**TOWN OF HERNDON, VIRGINIA
ARCHITECTURAL REVIEW BOARD
PUBLIC HEARING AGENDA
APRIL 17, 2019
HERNDON COUNCIL CHAMBERS BUILDING
765 LYNN STREET
7:30 P.M.**

Subject: ARB #19-13, 505 Huntmar Park Drive Antennas and Enclosures – Updates

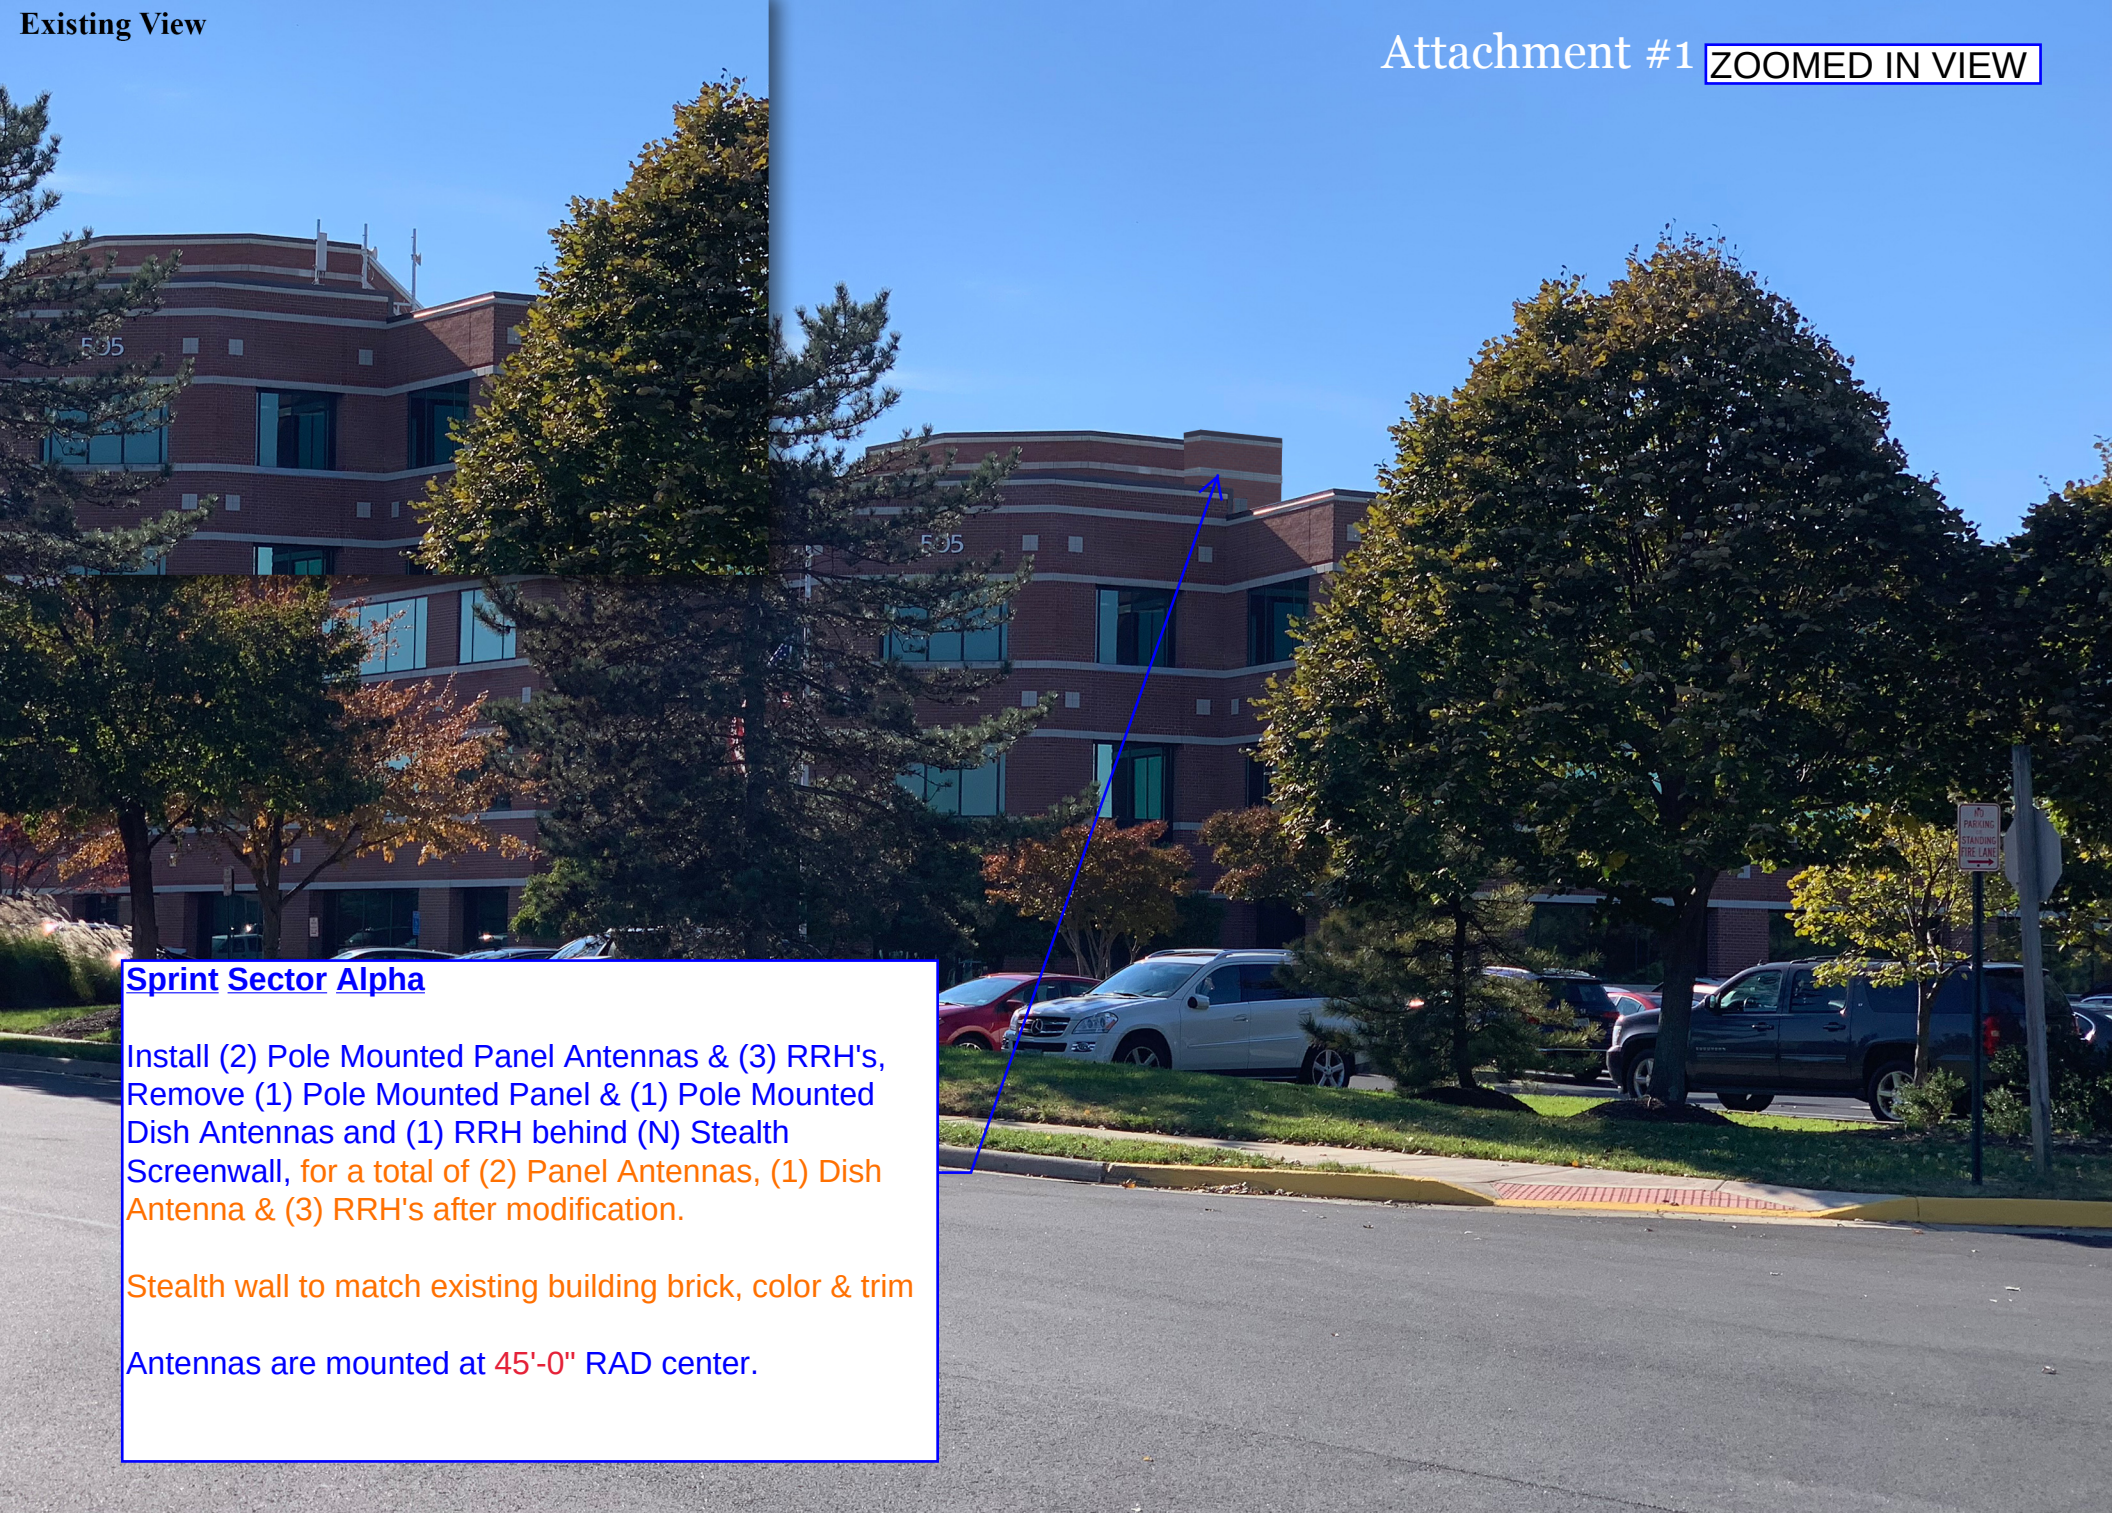
Staff has reviewed the stealth antenna enclosures and find the exterior design and texture will appear more in keeping with the existing architecture and materials of the commercial office building. While the exterior material of the enclosures will not be constructed of brick or brick veneer, the simulated brick material is of less contrast to the existing building materials than the previous design.

The enclosures will still noticeably break the roofline of the two wings of the building, however the texture, pattern and color rendition of the enclosures will appear more coordinated with the existing materials. After discussing options with the applicant, there are few design options that would not inhibit the function and operational optimization of the RF antenna systems at this location.

Staff recommends approval of ARB #19-13 with the following condition:

1. The proposed enclosures are installed in substantial conformance with the application and supporting materials as submitted February 11, 2019 and updates submitted on April 2 and April 11, 2019.
